Corporate Report

Originator's
Files OZ 07/019 W1

SUBJECT: **Information Report**
Official Plan Amendment and Rezoning Applications
To permit 47 townhouse dwellings under standard
condominium tenure
1125 and 1135 Haig Boulevard
East side of Haig Boulevard, north of Lakeshore Road East
Owner: Weldon Properties (Haig) Inc.
Applicant: Glen Schnarr and Associates Inc.
Bill 51

CONCEPT PLAN

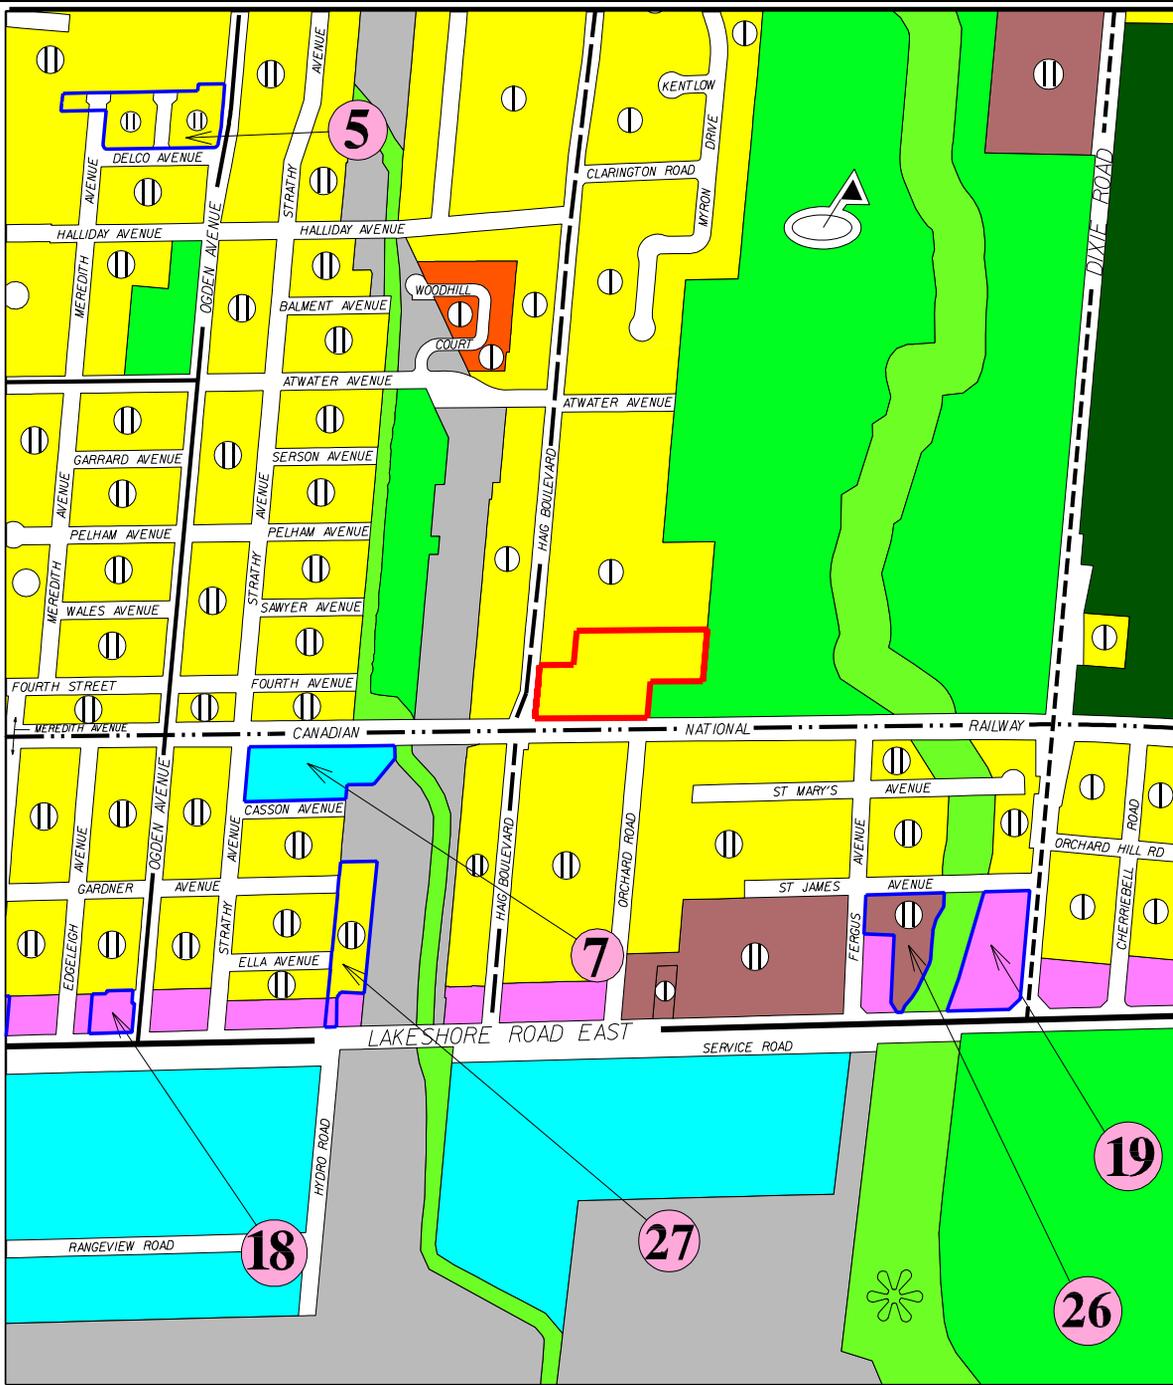
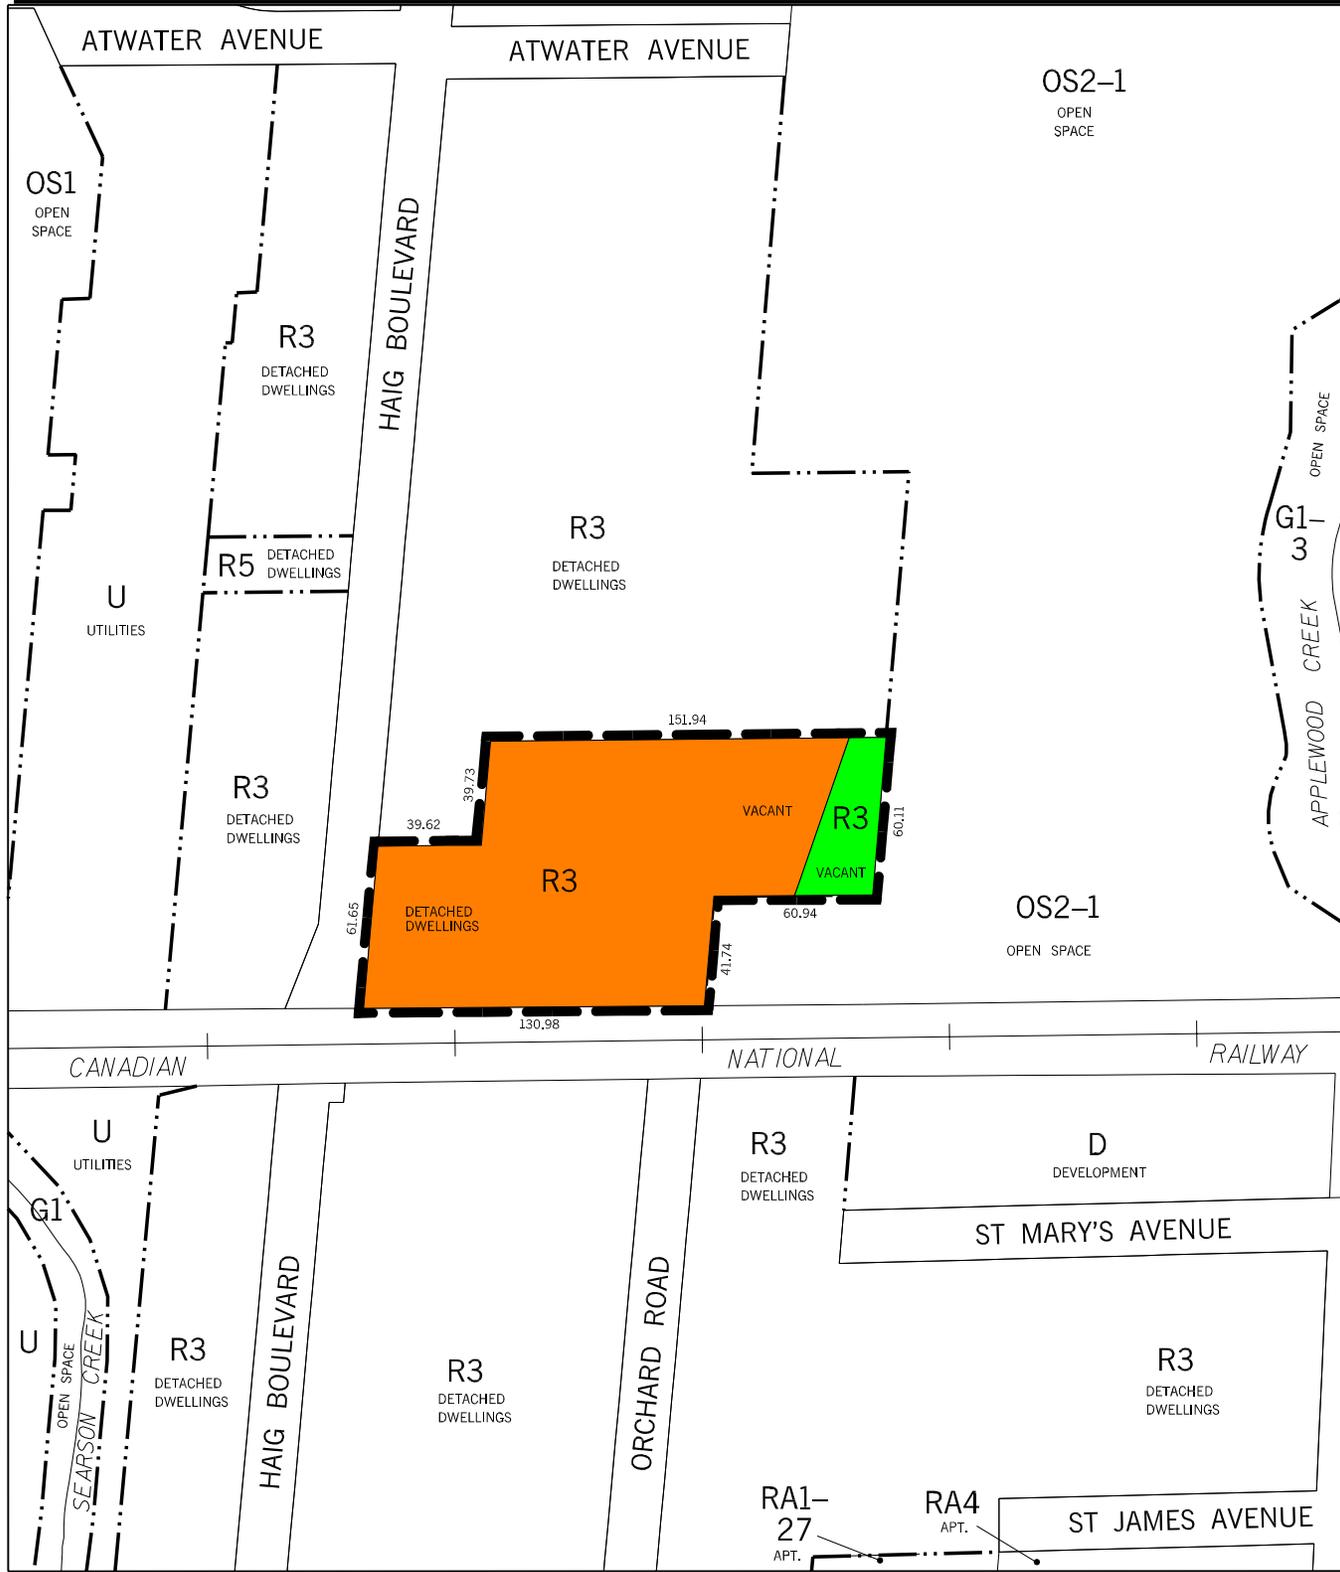
Changes to the concept plan have been requested to ensure that the proposed development addresses Haig Boulevard in an appropriate fashion. The revised concept plan (Appendix I-4) presently depicts vehicular access at the northerly most extent of the frontage, parallel visitor parking spaces, the end elevation of the westerly most block of townhouses and rear yard privacy fencing along the Haig Boulevard frontage. Specifically, the applicant has been requested to modify the concept plan to accommodate a similar type of built form and lot pattern to that which already exists along Haig Boulevard and to minimize the visual impact which may be associated with the proposed noise barrier.

The applicant has been advised of concerns with the proposed site layout. However, detailed comments pertaining to the ultimate site layout may be premature pending the determination of the most appropriate setback from the Lakeview Golf Course. On this basis, the applicant has been requested to consider modifications which would accommodate a more appropriate rear yard to rear yard interface with existing dwellings along Haig Boulevard, orient units to minimize noise barrier requirements, locate the required play space in a more appropriate location, a layout which would better accommodate redevelopment of adjacent lands to the north, alternative road configuration and would interface with the golf course in a more appropriate fashion. In regard to the interface of these lands with the golf course, such considerations will include setbacks, building orientation, location of private and communal amenity areas, road pattern and intervening structures and landscaping.
